**MONTGOMERY COUNTY HISTORIC PRESERVATION COMMISSION**  
**STAFF REPORT**

<b>Address:</b>	7200 Maple Avenue, Takoma Park	<b>Meeting Date:</b>	9/6/2023
<b>Resource:</b>	Outstanding Resource <b>Takoma Park Historic District</b>	<b>Report Date:</b>	8/30/2023
<b>Applicant:</b>	Elizabeth Baer & Daniel Eichner (Richard J. Vitullo, Architect)	<b>Public Notice:</b>	8/23/2023
<b>Review:</b>	HAWP	<b>Tax Credit:</b>	Partial
<b>Permit Number:</b>	1040006	<b>Staff:</b>	John Liebertz

**PROPOSAL:** Partial demolition and new construction.

Figure 3: View of the HAWP approved by the HPC in March 2022 (top) and the revised proposal submitted by the applicant (bottom).  
Source: Applicant.

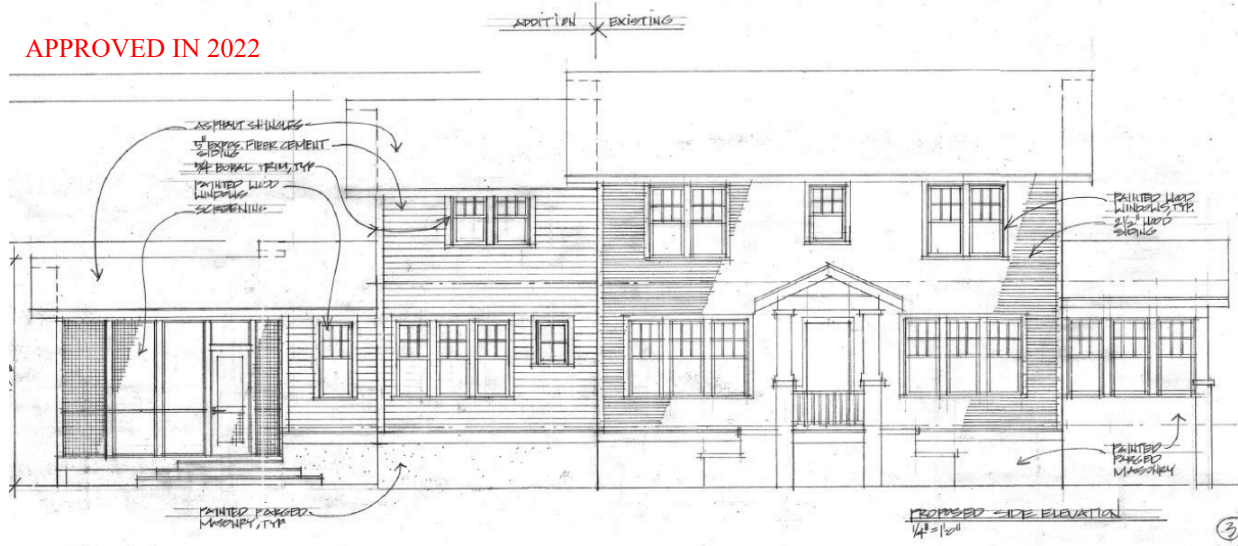
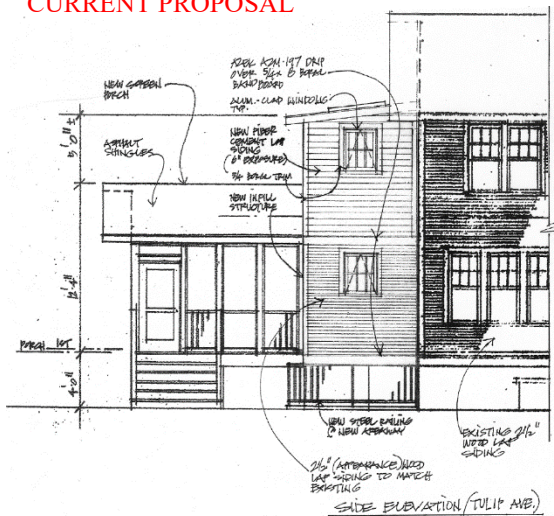
The Historic Preservation Commission reviewed and approved a much larger addition and screened-in porch submitted by the applicant at its March 23, 2022, meeting. For more information, see <https://montgomeryplanning.org/wp-content/uploads/2022/03/I.B-7200-Maple-Avenue-Takoma-Park-982698.pdf>. This proposal omits the approved demolition of the existing sleeping porch and construction of a new gable addition. Instead, it retains the form of the extant shed roof, rear addition and adds a new screened-in porch within the footprint of the existing deck (*Figure 3*).

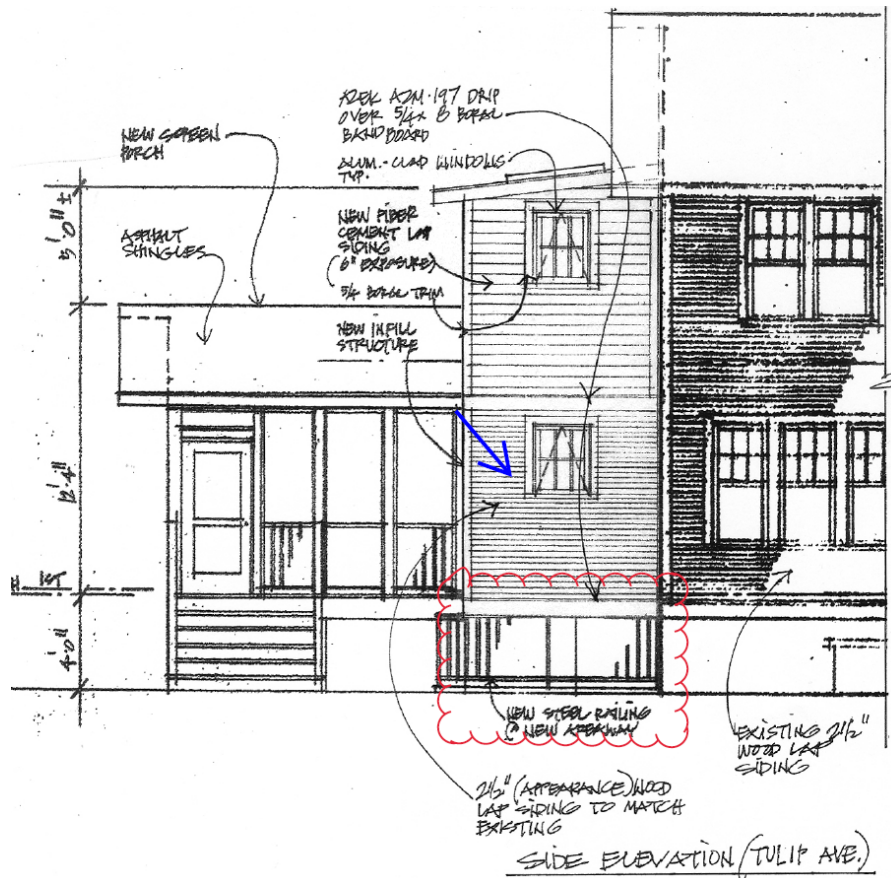
Staff finds the proposed materials to be consistent with the applicable guidelines and recommends approval with conditions. Staff requests the applicant label the proposed foundation for the infilled section of the rear addition; it should be parged CMU or a similar material to mimic the appearance of the existing masonry foundation of the historic house (Figure 4).

The proposal utilized wood lap siding (with a 2 ½” reveal) on the first story and cementitious fiberboard siding (with a 6” exposure) on the second story of the rear addition (*Figure 4*). The new wood siding, however, matches the historic house and provides a false narrative about the evolution of the property. Therefore, staff recommends the replacement of all wood lap siding with a smooth-finished, cementitious fiberboard siding (with a 6” exposure). The HPC regularly approves the use of substitute material on additions to Outstanding Resources in the historic district including the proposed cementitious fiberboard siding and cellular polyvinyl chloride and poly-ash trim.

*Figure 4: View of the proposed south elevation. The blue arrow points to the proposed wood lap siding with a 2 ½” reveal. Staff recommends replacement of this siding with cementitious siding with a 6” exposure. The area noted with the red cloud shows the foundation that requires a note about material.*

1. The applicant shall submit specifications for the new foundation (infilled section of the existing addition).
2. The applicant shall remove and replace the proposed wood lap siding with a 2 ½” reveal with the smooth finished, cementitious fiberboard siding (with a 6” exposure) on the first story of the rear addition.

**Figure 5: View of the proposed north elevation. Staff requests a specification sheet for the door noted with the red cloud.**

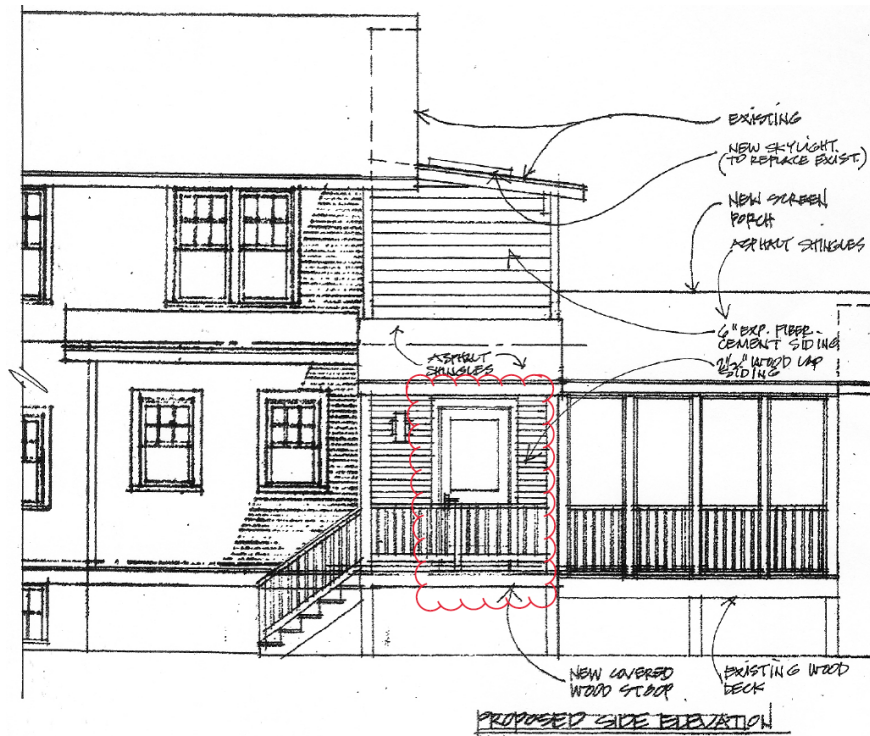
Staff finds the proposed wood sliding glass doors accessing the screened-in porch and the single-light, single-leaf wood door on the new covered entry in the northwest corner of the house to be compatible with the historic house. These doors would have no or limited visibility from the public right-of-way, and therefore, would have no adverse effect. Staff requests that the applicant submit a specification sheet for the proposed single-leaf door (*Figure 5*).

4. The applicant shall revise the note on the rear elevation from “new wood windows” to “new aluminum-clad widows.”
5. The applicant shall submit specifications for the single-leaf door on the north elevation.
